Charlotte Department of Transportation

Memorandum

Subject: Rezoning Petition 14-005: Approximately 0.39 acres located on the north side of Central Avenue between St. Julien Street and Westover Street.

Figure 1

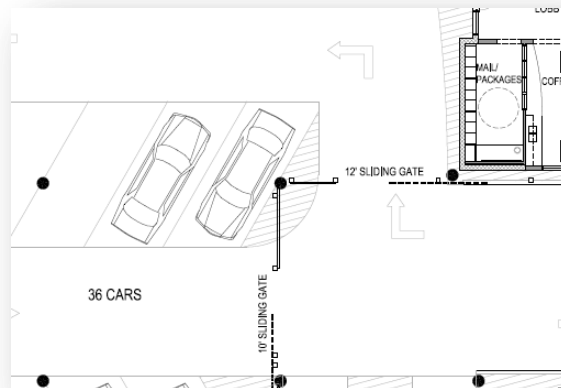
1. In locations where the sidewalk abuts the proposed building, we request the petitioner increase the proposed sidewalk dimension from 6' to 8' along the entire site.
2. We request the petitioner adjust the proposed security gate pole location (Figure 1). As shown, it does not appear that a parked car door could open completely without hitting the pole.
